1 Columbia Avenue, Takoma Park
(HPC Case No # 37/03-08X)
Takoma Park Historic District

RETAIL-OFFICE STRUCTURE

SUBJECT: Historic Area Work Permit #483107, porch stair installation, sign installation and parking area modifications

Address: 1 Columbia Avenue, Takoma Park **Meeting Date:** 5/14/2008
Resource: Contributing Resource **Report Date:** 5/7/2008
Takoma Park Historic District
Applicant: Maraline Trager **Public Notice:** 4/30/2008
Review: HAWP **Tax Credit:** None
Case Number: 37/03-08X **Staff:** Josh Silver
PROPOSAL: Porch stair installation, sign installation, and parking area modifications

PROPOSED SITE PLAN

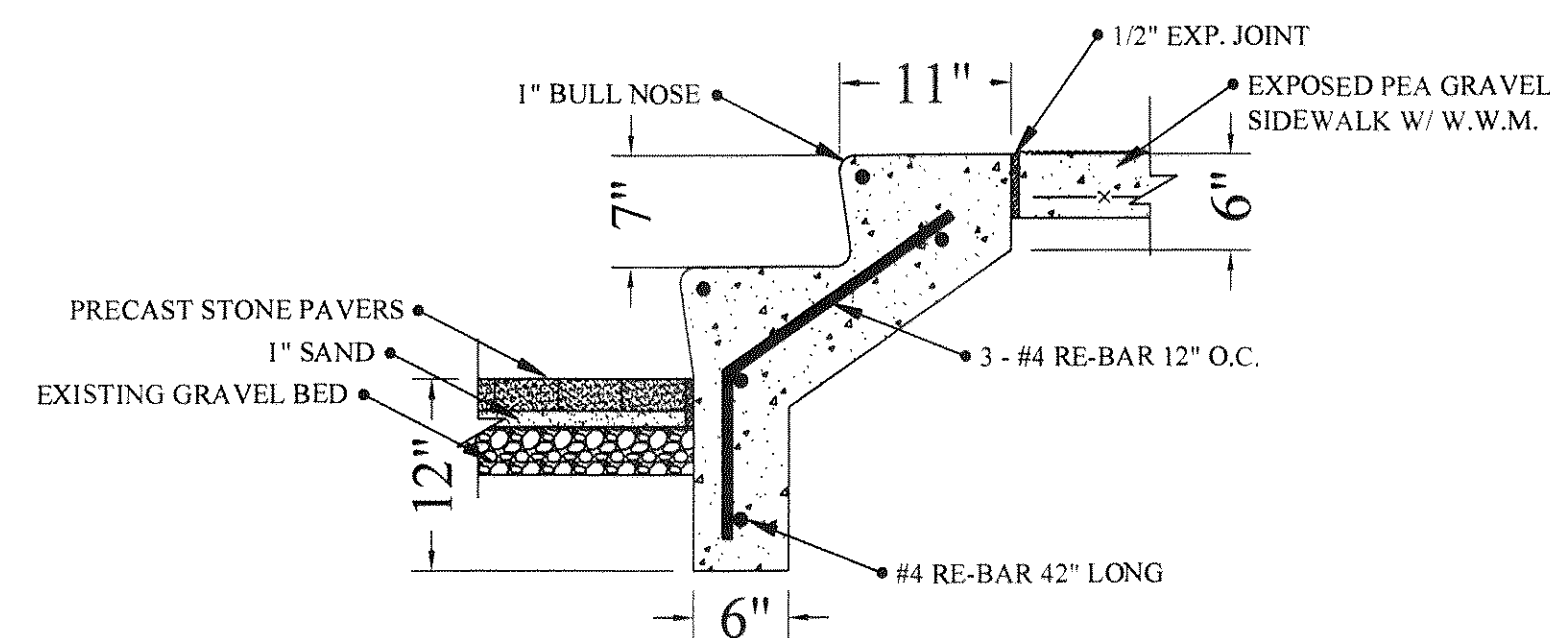
- General:
 - Obtain all required permits and approvals before starting construction.
 - Grade parking area to receive stone pavers and place same. *THE PROPOSED PARKING AREA MODIFICATION IS NOT APPROVED. SEE ATTACHED HPC MEMO [JTS 7/1/2008]*
 - Place new sidewalks as per plans.
 - Place rear stairs as shown on plans.
 - Replace existing sign with ne sign as shown on plans.
 - Complete all interior finishes and remove all trash and building materials from site.
 - Obtain all final inspections along with occupancy permits.

PROPOSED SITE PLAN

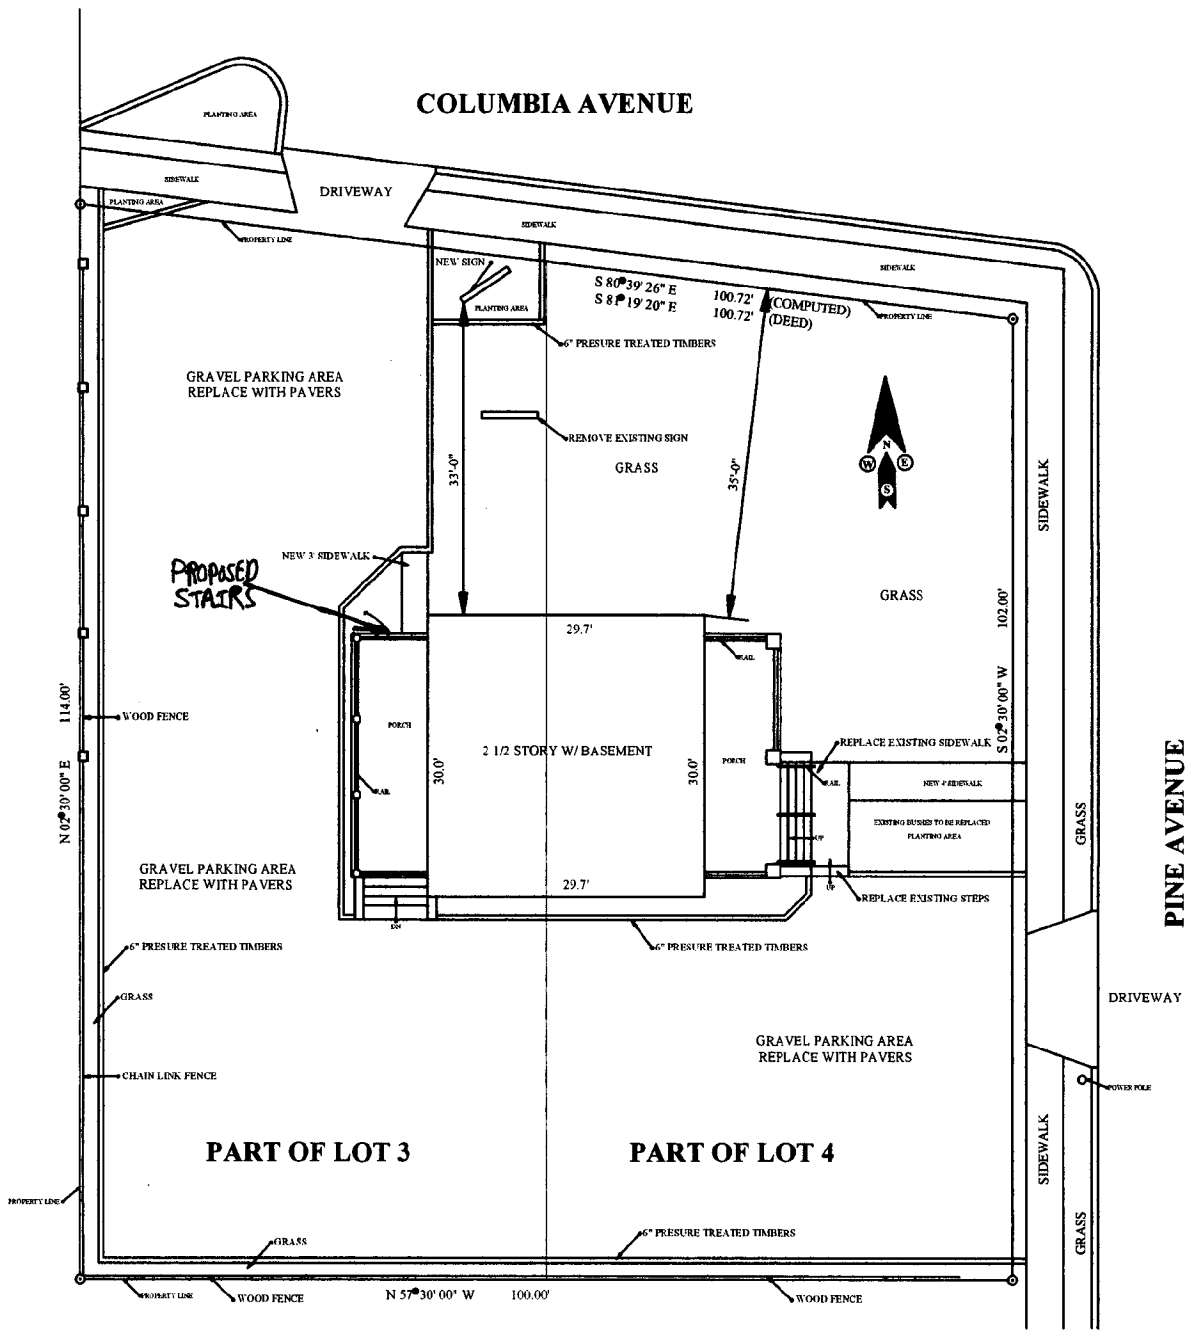
Although it is not uncommon for the HPC to approve the installation of pavers within the limits of an existing driveway, staff does not support the proposed installation of precast pavers at this property. The existing gravel driveway currently covers approximately 75% of the existing property. The installation of precast pavers in this location would have a major impact on the streetscape of the historic district and to a property that is already undergoing several noticeable modifications. Staff understands the applicant intends to use the property for commercial purposes, and that a more permanent driveway surface is desirable. Staff is not opposed to a more permanent driveway surface at the property. However, the introduction of a more permanent parking area surface should be reduced to mitigate any potential impact to the streetscape of the historic district.

Staff recommends the applicant continue to address the following concerns in order for staff to assess the appropriateness of the proposed modifications at the property:

1. Submit a revised proposal to HPC staff showing the proposed staircase on the south end of the porch and the door and window retained in the existing location
2. Submit a revised sign specifications sheet indicating an all wood sign will be utilized
3. Explore using an exposed aggregate concrete or similar application for the proposed front sidewalk
4. Explore the feasibility of reducing the size of proposed permanent parking area.
